Access Compliance Report

Public Rights-of-Way

(Curb Ramps)

Intersection ID: 47090	Main Street: PROVIDENCE_RD_WEST	Cross Street: COVENTRY_COURT_LN	Location: SE
ADA ID: 525FD1396722	Ramp Type: PerpDiag	Initial Pass/Fail: Fail	Overall Compliance: No
Severity Score: 12.5			
Codes/Mitigation Info/Possible Solution		Field Measurements/Component Compliance

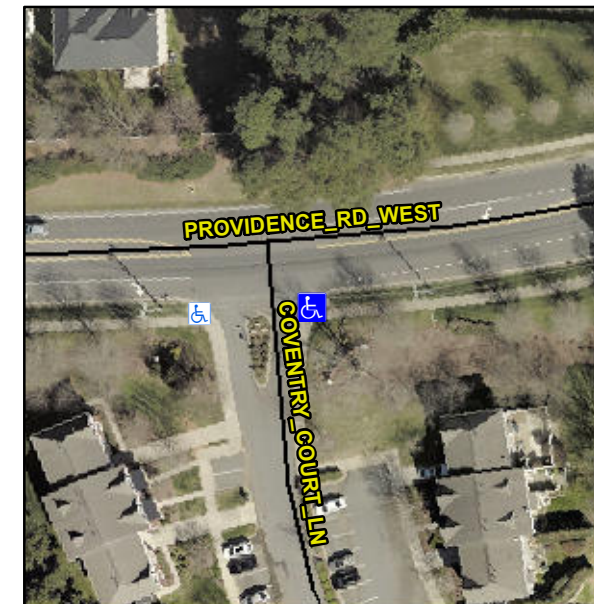
Not Found, R304.2.2

Compliance	Description	Data	Compliance	Description	Data
N/A	Ramp Length (in)	62.0	No	Ramp Slope (%)	8.9
Yes	Ramp Width (in)	48.0	Yes	Ramp XSlope (%)	1.7
N/A	Flare Type LT	N/A	N/A	Flare Type RT	N/A
N/A	Flare Slope LT (%)	N/A	N/A	Flare Slope RT (%)	N/A
N/A	Flare Traversable LT?	N/A	N/A	Flare Traversable RT?	N/A
N/A	Landing Length (in)	N/A	N/A	DWS Provided?	N/A
N/A	Landing Width (in)	N/A	N/A	DWS Contrast?	N/A
N/A	Landing Slope (%)	N/A	N/A	DWS Length (in)	N/A
N/A	Landing X Slope (%)	N/A	N/A	DWS Full Width?	N/A
N/A	Landing Curb? (Y/N)	N/A	N/A	DWS Offset (in)	N/A
N/A	Shared Landing?	N/A			
N/A	Gutter Ponding?	N/A	N/A	Gutter Slope (%)	N/A
N/A	Gutter Lip Ht (in)	N/A	N/A	Gutter X Slope (%)	N/A
N/A	Painted X Walk1?	No	N/A	Painted X Walk2?	No
	X Walk 1 Direction	To N		X Walk 2 Direction	To W
N/A	X Walk 1 Width (in)	N/A	N/A	X Walk 2 Width (in)	N/A
	X Walk 1 Slope (%)	2.6		X Walk 2 Slope (%)	0.7
	X Walk 1 X Slope (%)	0.3		X Walk 2 X Slope (%)	1.1

Remove & Replace Curb Ramp With Two New Directional Ramps or Equivalent.
